Suite 403/404 - ORIGINAL LAYOUT

PURCHASER'S EXTRAS (PE)

Hampton Place - Braylea Investments Inc.

LOT NUMBER	PHASE	HOUSE TYPE	REG. PLAN #		
403 404	1	MAIDSTONE

* Laundry Room Layout

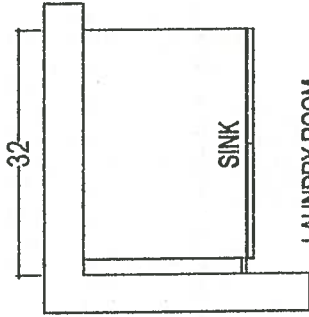
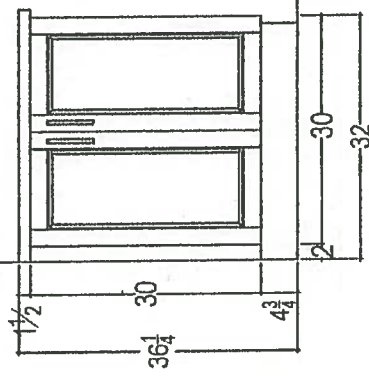
1		1 - LAUNDRY ROOM - Laundry Room vanity to be relocated to entrance of laundry room. Laundry Vanity to be adjusted accordingly. Vanity width to be approx. 32" Location of washer & dryer to be installed towards rear of laundry room. Note: Due to On-Site Conditions - As per Fonzie C. (See Attached Revised QTK Lauout & Suite Layout)	
---	--	--	--

*Raised Vanity
* STD Top Mount Sink +
STD Faucet

KITCHEN = SEE **PLAN OUT**

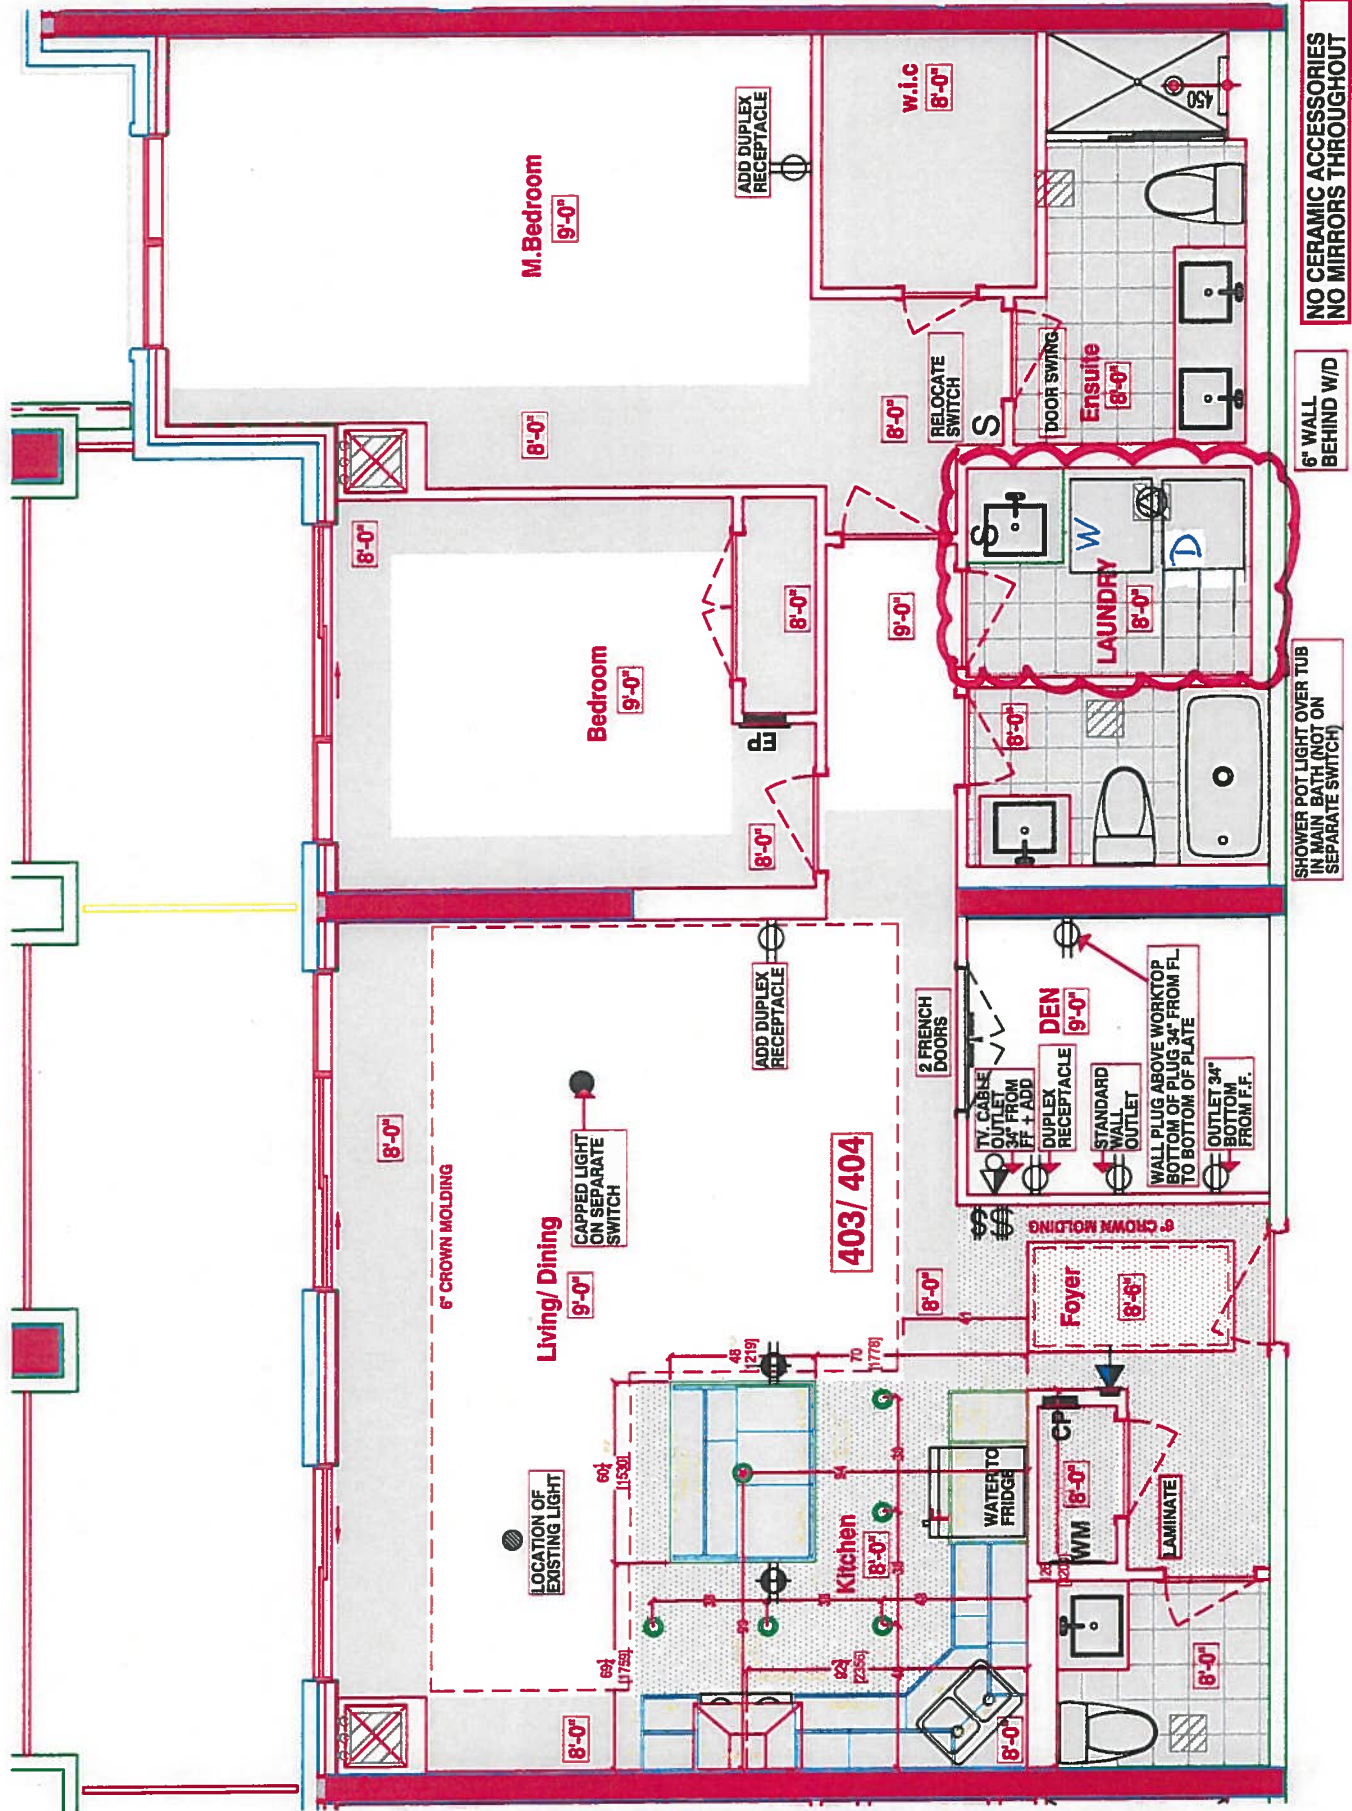
DROP CEILING IN KITCHEN
RELOCATE STANDARD LIGHT
FIXTURE TO CENTER
OF KITCHEN ISLAND

LOCATION OF KITCHEN PLUGS
LIGHTS REFER TO QTK. DWG.

3. WIRING IN ISLAND
A: OUTLETS AS REQ'D BY CODE
B: WINE COOLER
C: MICROWAVE DRAWER

- UPG #2 - APPLIANCE PKG, W/ SPECIAL FRIDGE
- (x6) = PUCK LIGHTS
- (x2) = PLUGS ISLAND
- (x1) - RELOCATE STD LIGHT OVER ISLAND SEPARATE SWITCH (STD)
- (x5) POTS IN KITCHEN (SEP. SWITCH)
- ISLAND WIRING FOR PUCKS + WINE COOLER
- REVISED DROP IN KITCHEN DUE TO EXTENDED KITCHEN ⊕ ISLAND MOVED TOWARDS LIVING ROOM.
- DELETE STD BACKSPASH
- POWDER ROOM + HAND + ENSUITE RAISED 36 1/4" VANITIES + DELETE 3" SPURST
- LAUNDRY VANITY RAISED 36 1/4" w/ STD TUB MOUNT SINK + STD FANUCET.

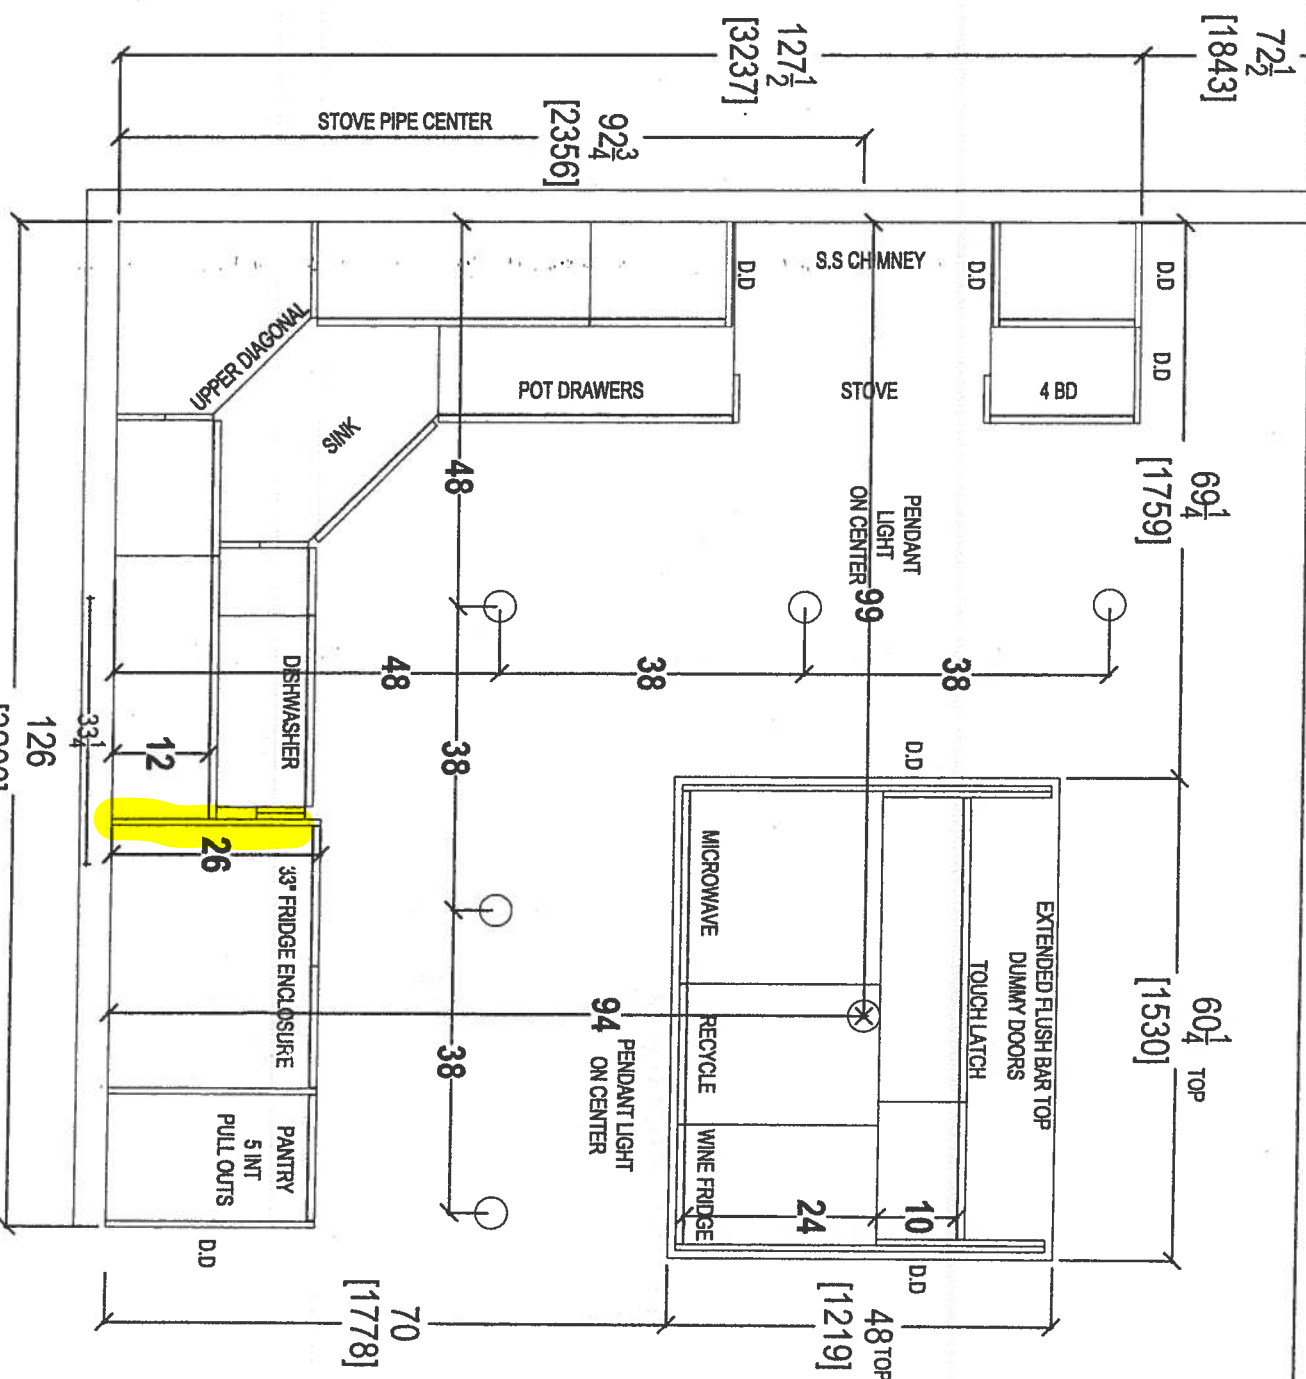
1 - KITCHEN- Install an additional 15" of dropped ceiling in the kitchen area.
Shift the Dining Rm Ceiling light towards the patio sliders to accommodate the increased dropped ceiling
lights to be shifted and adjsuted accordingly- Refer to QTK sketch
Approved by Vince
No charge as per Steve C

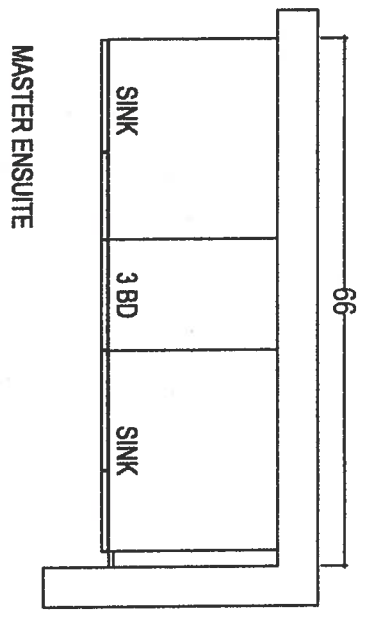
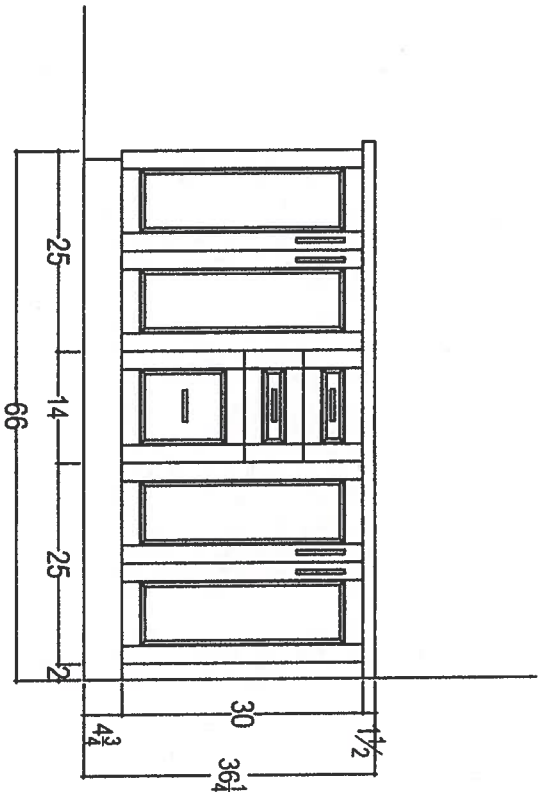
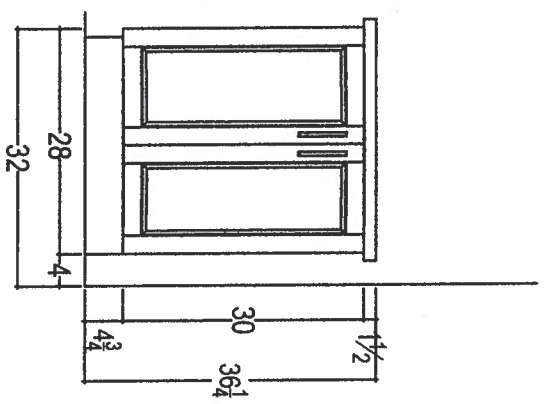
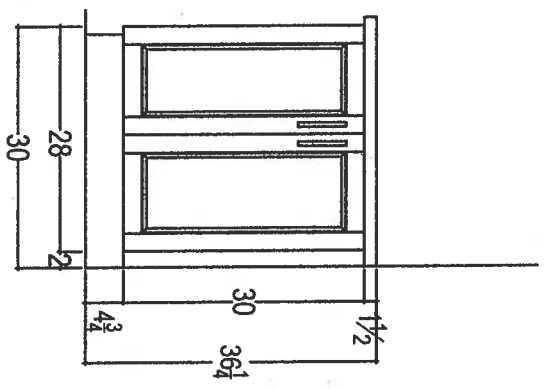
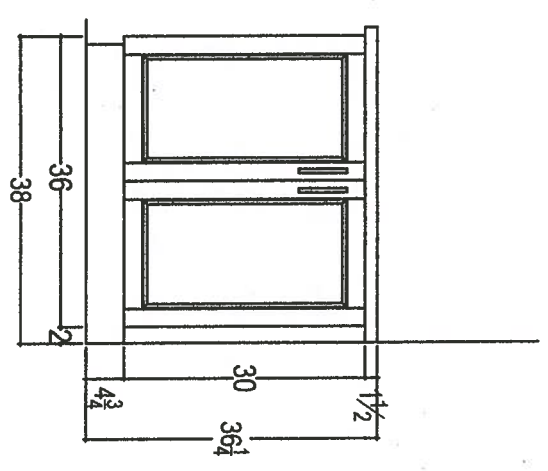
* RAISED VANITY *
STD TOP MOUNT SINK
+ STD FAUCET

* RAISED VANITIES *
DELETE 3" SPLASH

* RAISED VANITIES *
DELETE 3" SPLASH
